FINAL DEVELOPMENT PLAN APPLICATION

Project/Property Address or Location: 6579 Taylor Rd.		Project Name/Business Name: Eastgate Commercial Park	
Parcel ID No.(s): 027-000008-00	Zoning Designation: OCT	Total Acreage: 7.6	
Project Description: Two 21,000sf Flex industrial buildings. Three 8,520sf Flex industrial buildings.			
APPLICANT Name -do <u>not</u> use a business name: Robert M. LeVeck		Applicant Address: 1500 W. Third Ave. Ste. 120 Columbus, OH 43212	
Applicant E-mail: rleveck@leveckconstruction.com		Applicant Phone No.: 614-582-4765	
BUSINESS Name (if applicable):			
ADDITIONAL CONTACTS: Please list Primary Contact person for Correspondence (please list all applicable contacts)			
Name(s):		Contact Information (phone no./email):	
PROPERTY OWNER Name: (if different from Applicant) Julie A. Faist		Property Owner Contact Information (phone no./email): 614-475-6677/julie.faist@gmail.com

Attn: Kelly Wicker, Administrative Assistant
RE: Project 6579 Taylor Rd Design Review Comment Letter Submittal 2
Project 6579 Taylor Rd Final Development Plan Comment Letter Submittal 2

PLANNING AND DEVELOPMENT STAFF REPORT

A LANDSCAPE PLAN
SCALE: 1"=40'-0"

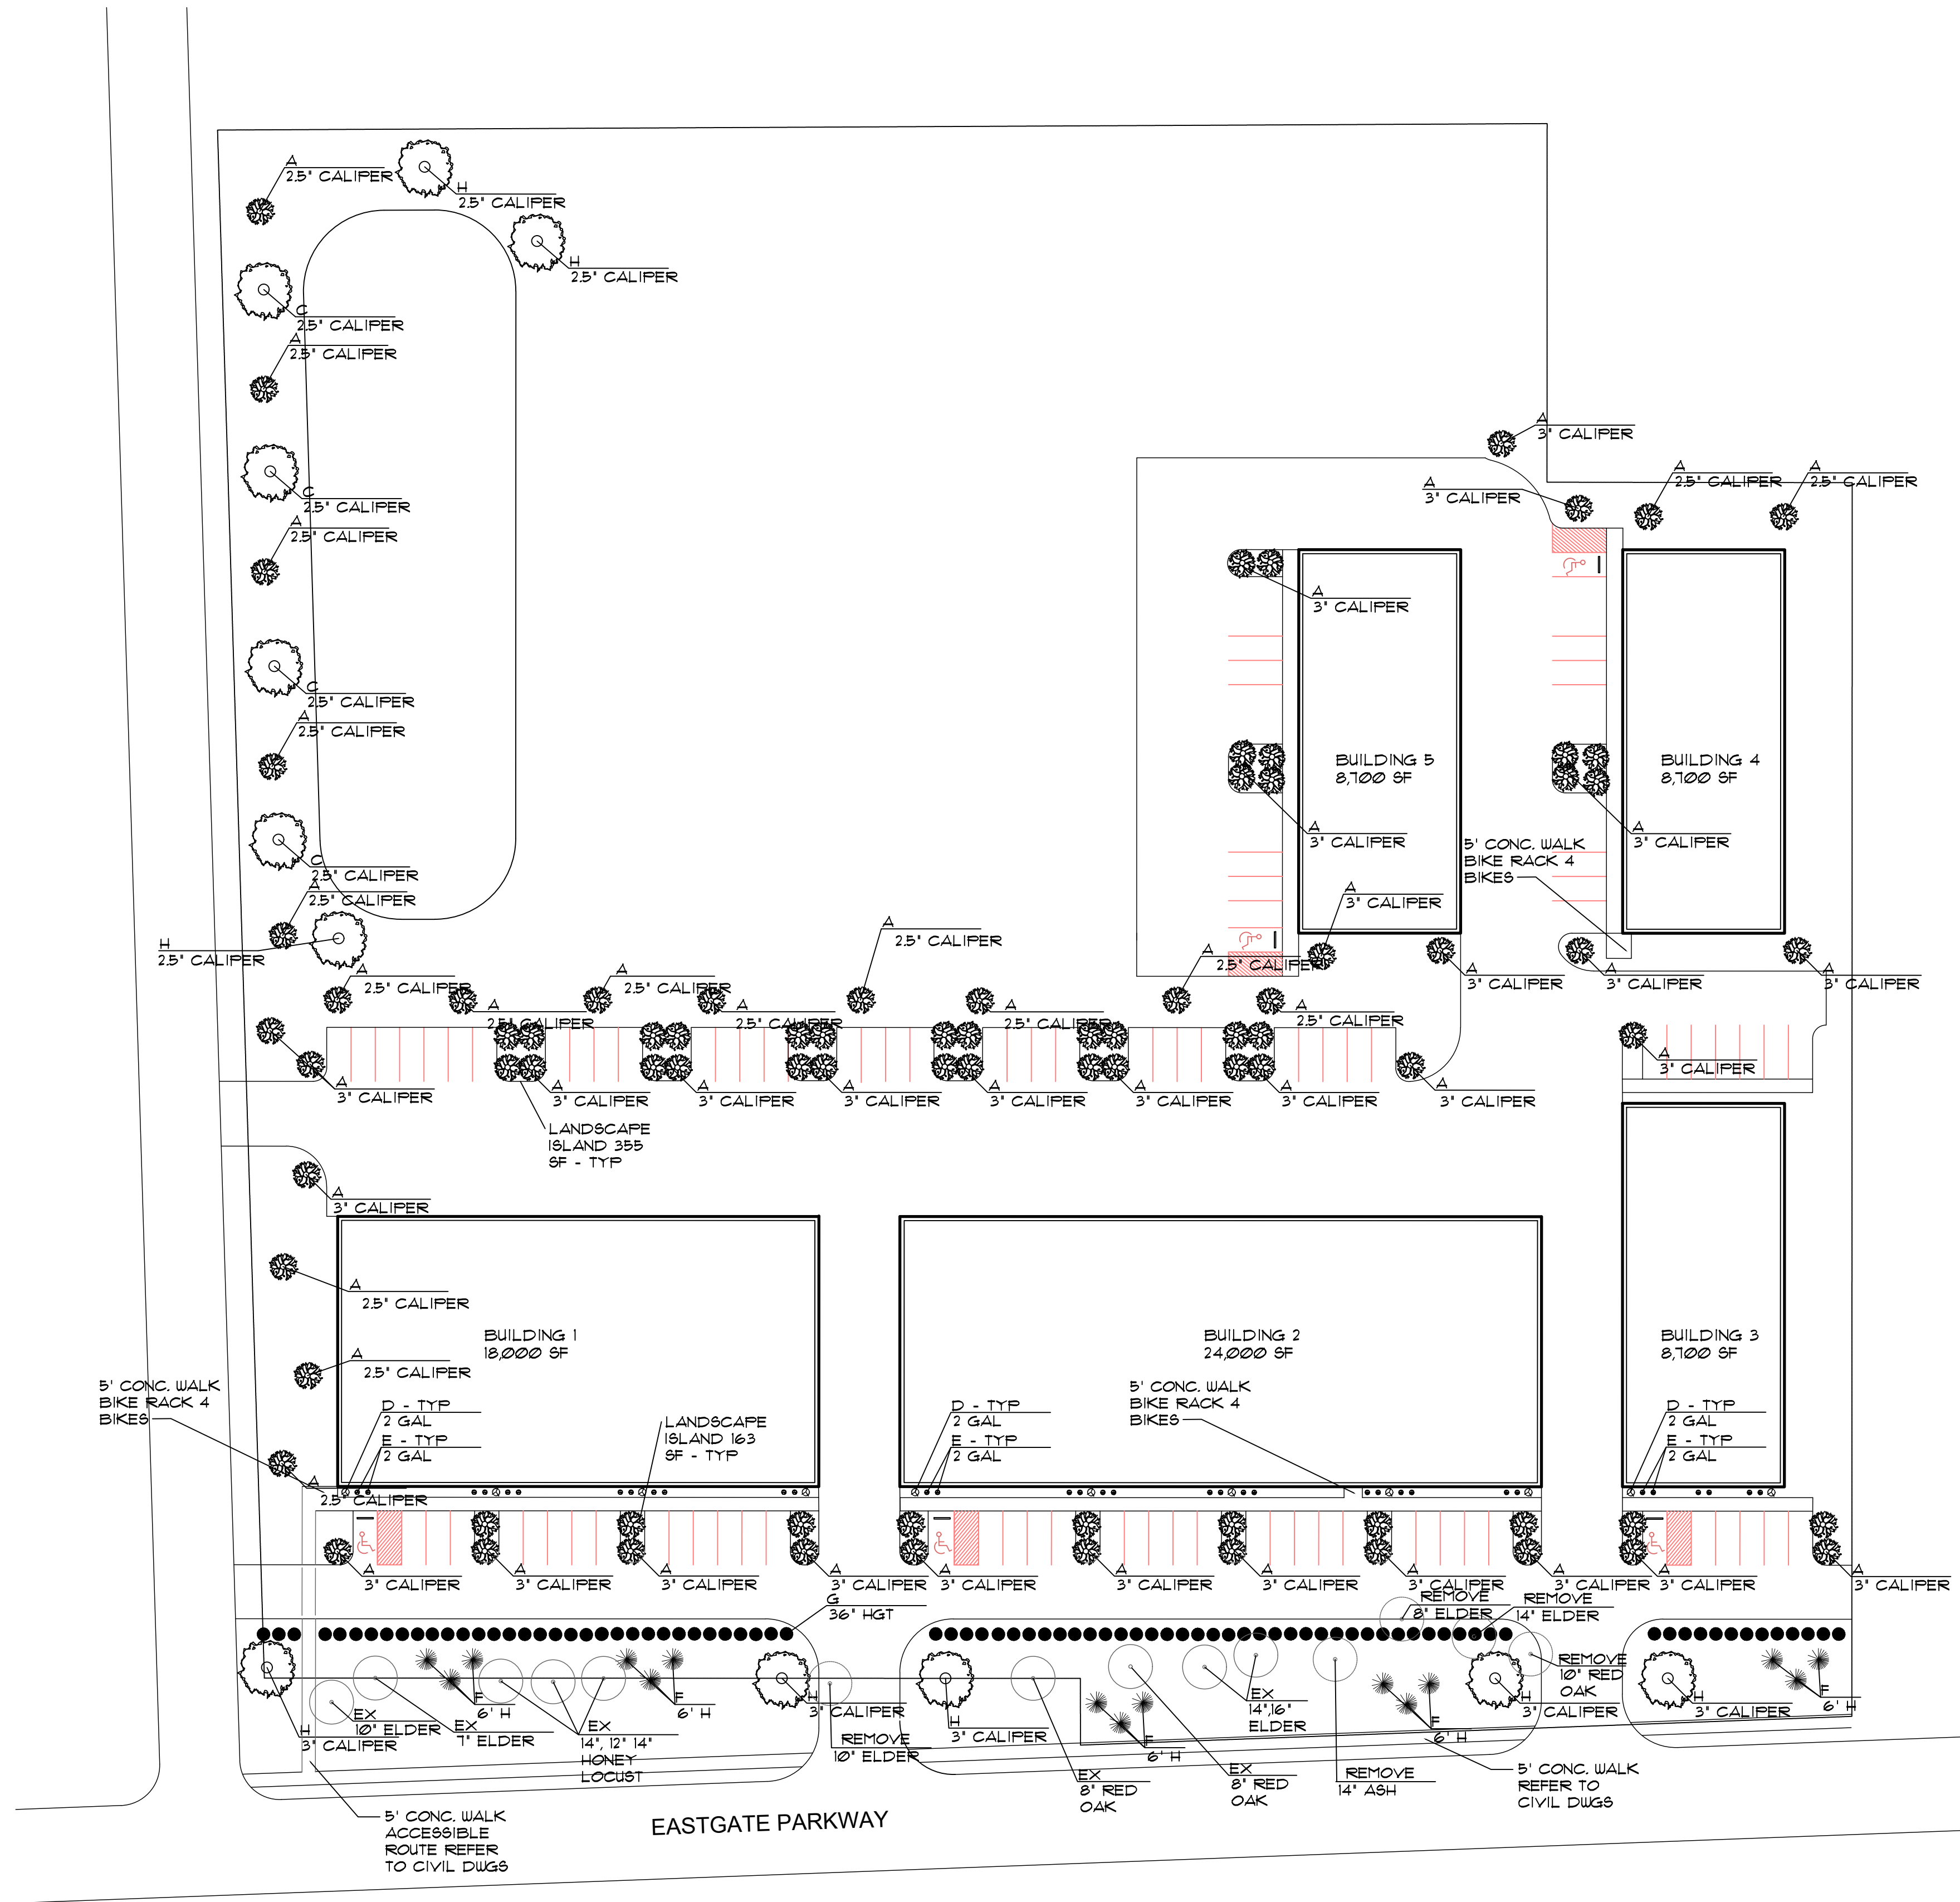
3. I am glad to see that barberry and burning bush were replaced with other species. I would like to note that red maples often struggle in parking lot islands. A hybrid maple may tolerate the environment better than a red maple.

5. I am glad to see that barberry and burning bush were replaced with other species. I would like to note that red maples often struggle in parking lot islands. A hybrid maple may tolerate the environment better than a red maple.

8. The landscape plan needs to calculate the parking area (spaces and drive aisles). The square footage of required landscape islands is 5% of the parking area. 1 tree per 100 square feet of required landscape island is required. The minimum tree caliper size is 3". Please revise the landscape plan for this calculation and increase the minimum tree caliper size.

8/20/19 - Based on the data provided, 46 trees need to be planted in the parking area, it appears that only 32 trees are planted. An additional 14 trees are required. Please revise accordingly.

9. The landscape plan shows barberry bushes at 24" in height planted along the parking area. No issues with barberry being planted as it is considered an evergreen, however, the minimum height is 36". Please revise accordingly.

8/20/19 - The landscape plan was revised to indicate that the parking lot screening will be accomplished by "Clethra Alnifolia". This bush is not an evergreen and therefore doesn't meet the requirements of the code. Additionally, the labeling on the landscape plan still indicates a planting size of 24". Please revise accordingly.

10. Chapter 914 requires one tree inch to be planted per 1,000 square feet of impervious surface. This requirement is in addition to any other planting requirements. Please revise the landscape plan accordingly.

8/20/19 - The landscape plan does not appear to have been revised. Please add to the table some indication of the requirements and the plantings or preserved trees that meet this requirement.

RESPONSE: Sugar Maple has been utilized in parking lot islands, however based on your code of 1 tree per 100 sf of landscape island, placing 4 3" caliper trees in an area seems to be asking for them to struggle to survive.

RESPONSE: Sugar Maple has been utilized in parking lot islands, however based on your code of 1 tree per 100 sf of landscape island, placing 4 3" caliper trees in an area seems to be asking for them to struggle to survive.

RESPONSE: We show the calculation for the 5% parking area as required landscape islands. Further we have added additional trees to the landscape islands, 4 per island of 355+/-SF and 2 per island of 167 +/-SF. These are shown as 3" caliper trees.

RESPONSE: We have revised this to Chinese Juniper

RESPONSE: Additional trees have been added. Existing trees to remain has been taken into account in determining the number of trees, at 2.5" per code, that have been required.

BUILDING 4&5 FRONT ELEVATION

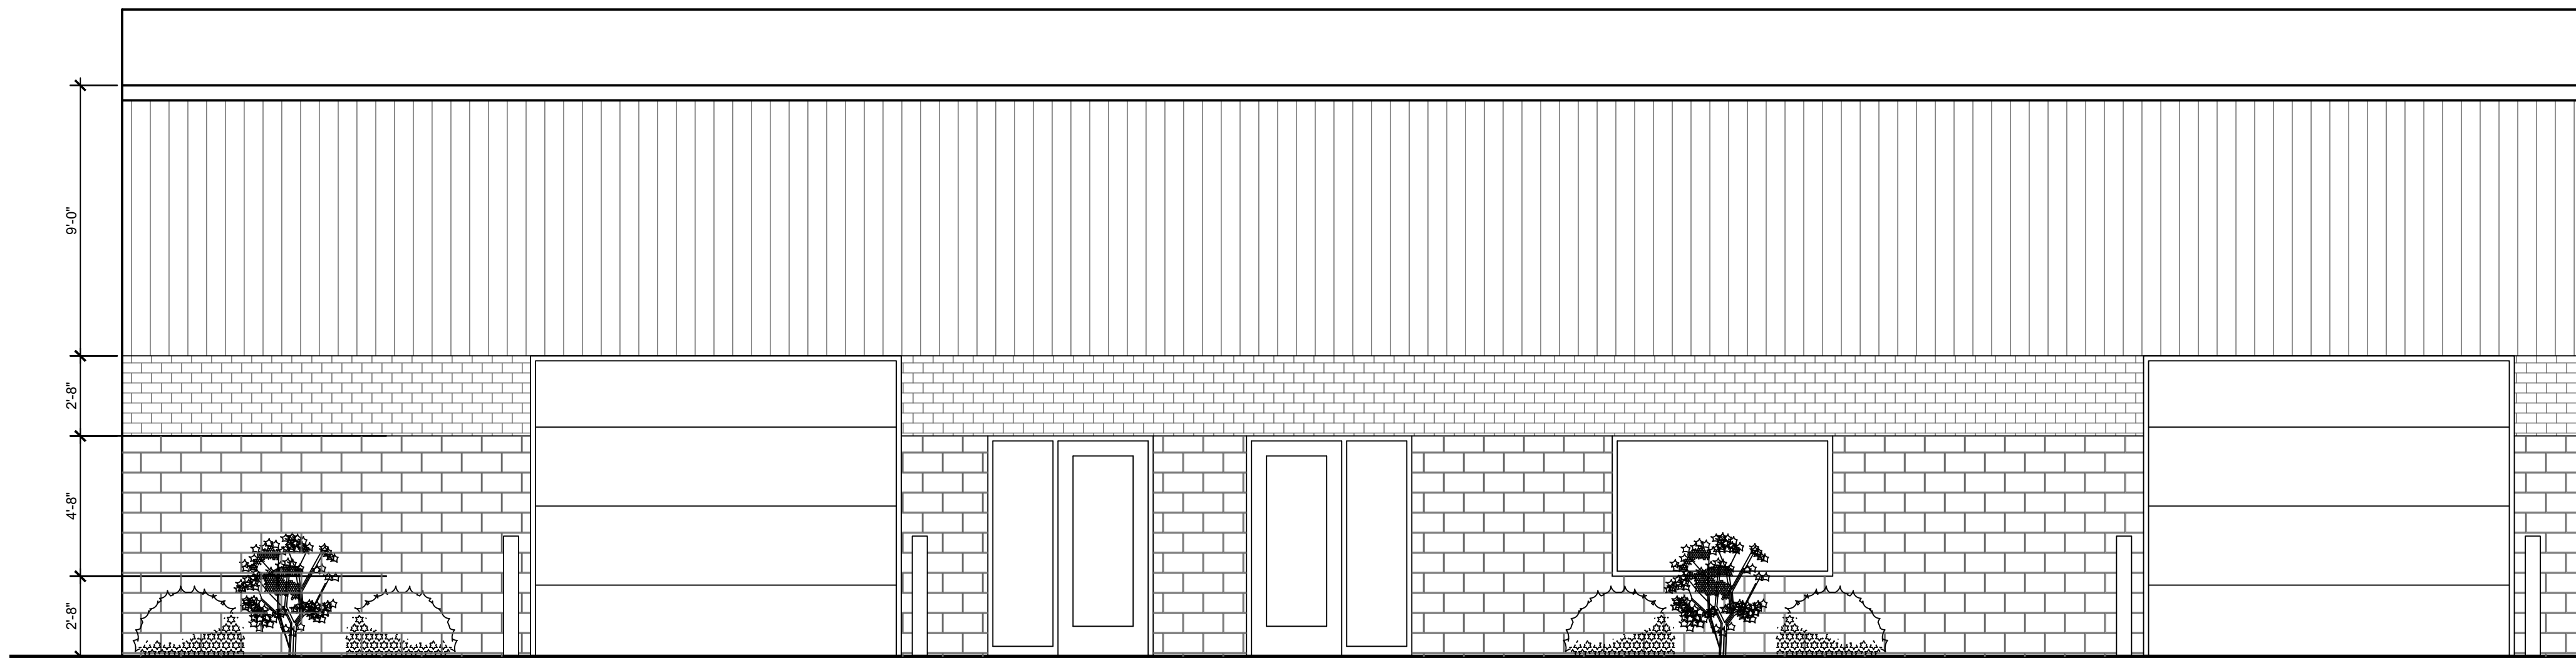
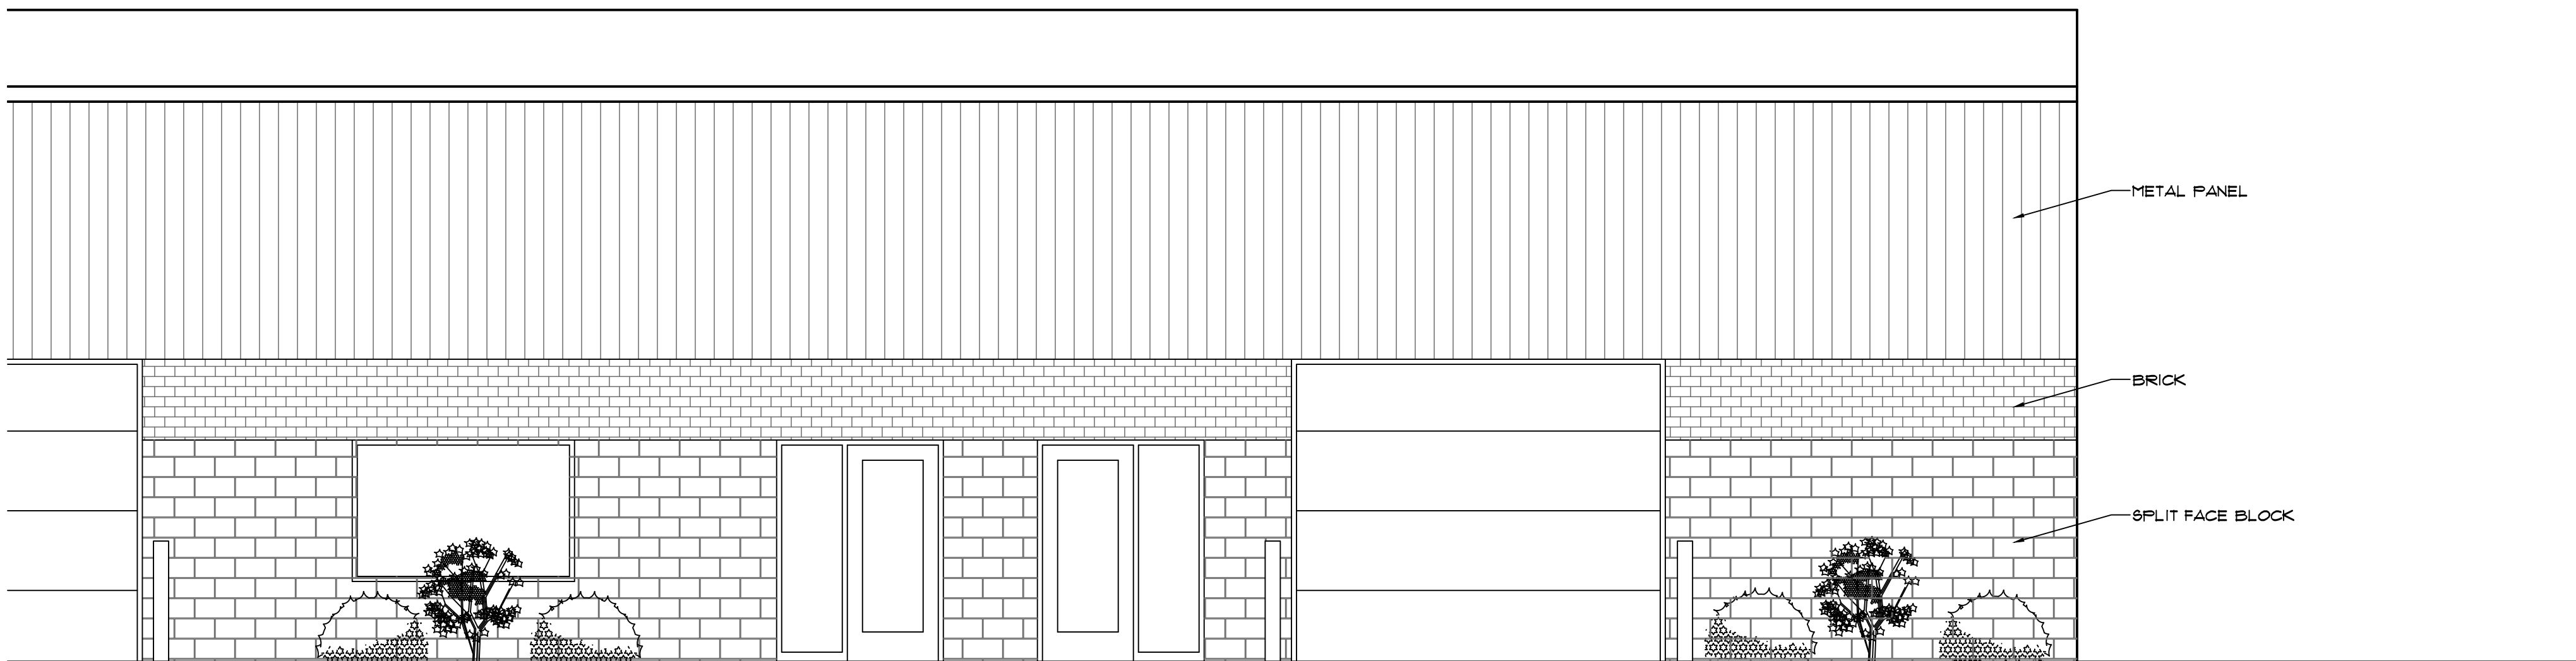
12. 8/20/19 - *The revised elevations depict a loading dock on the front elevation (see sheet A3.07). Chapter 1155.04(e)(3)(A) prohibits loading docks on the front elevation. Please either revise the elevations or the variance application.*

RESPONSE: Sheet A3.07 (now A3.08) reflects the Front Elevation of Buildings 4&5. This elevation faces internal to the site and not to a public way or adjacent parcel. The label "Front Elevation" is merely an architectural convention for labeling the elevations of a building and does not reflect "Street Frontage Elevation", or Main Façade, which is what Chapter 1155.04(e) is addressing.
